Product Change Notification / SYST-230UGH321

ERRATA - dsPIC33CH128MP508 Family Silicon Errata and Datasheet Clarification

dsPIC33CH128MP508 Family Silicon Errata and Data Sheet Clarification

FIGURE 1: I/O RAMP

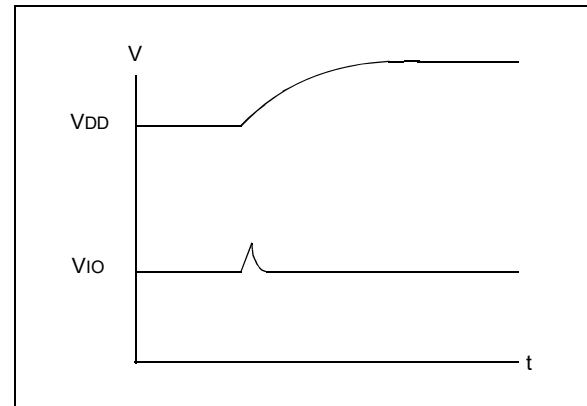
26. Module: I/O

During a fast device power-up, when the V_{DD} ramp is less than 4 mS, the I/O pins may drive up to 100 μ A current for a duration of up to 10 μ S (Figure 1).

1. Slow down the V_{DD} ramp time (greater than 4 mS for V_{DD} to ramp 0V to 3.3V).
2. Ensure the circuitry that is connected to the pins can endure this pulse.

Example applications affected may include complementary power switches, where a transient current shoot-through might occur.

High-voltage applications with complementary switches should power the high-voltage 200 μ Sec later than powering the dsPIC[®] device to avoid the current shoot-through. This behavior is specific to each device and not affected by aging.

FIGURE 2-2: SUGGESTED PLACEMENT OF THE OSCILLATOR CIRCUIT

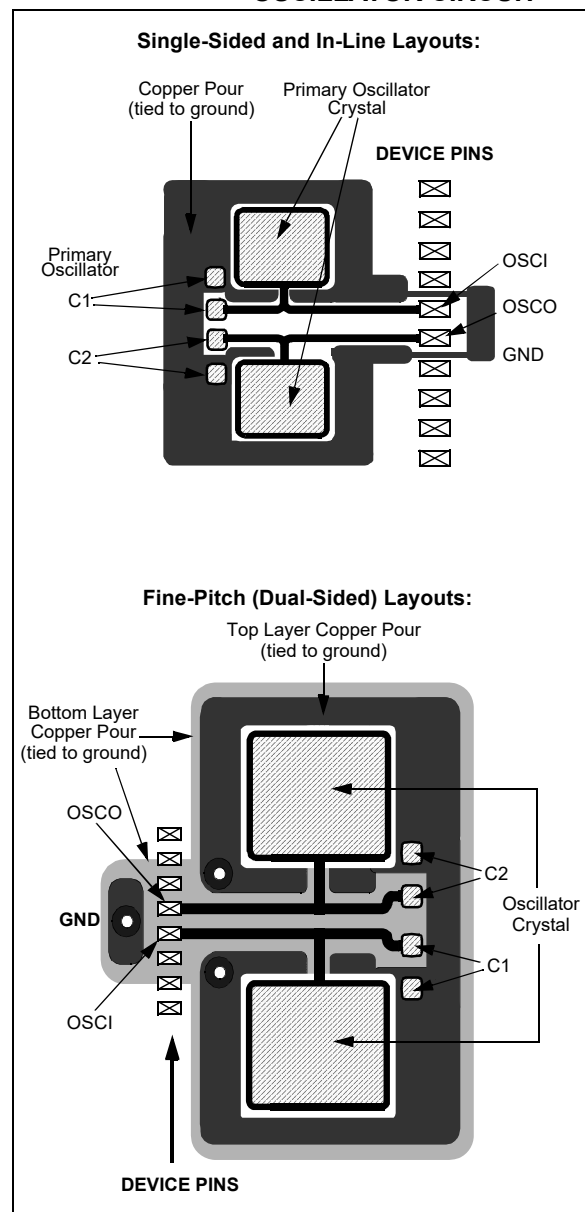
Additional information is added to [Section 2.5 “External Oscillator Pins”](#) and [Section 2.6 “External Oscillator Layout Guidance”](#) is added.

2.6 External Oscillator Layout Guidance

Use best practices during PCB layout to ensure robust start-up and operation. The oscillator circuit should be placed on the same side of the board as the device. Also, place the oscillator circuit close to the respective oscillator pins, not exceeding one-half inch (12 mm) distance between them. The load capacitors should be placed next to the oscillator itself, on the same side of the board. Use a grounded copper pour around the oscillator circuit to isolate it from surrounding circuits. The grounded copper pour should be routed directly to the MCU ground. Do not run any signal traces or power traces inside the ground pour. If using a two-sided board, avoid any traces on the other side of the board where the crystal is placed. Suggested layouts are shown in [Figure 2-2](#). With fine-pitch packages, it is not always possible to completely surround the pins and components. A suit-

able solution is to tie the broken guard sections to a mirrored ground layer. In all cases, the guard trace(s) must be returned to ground.
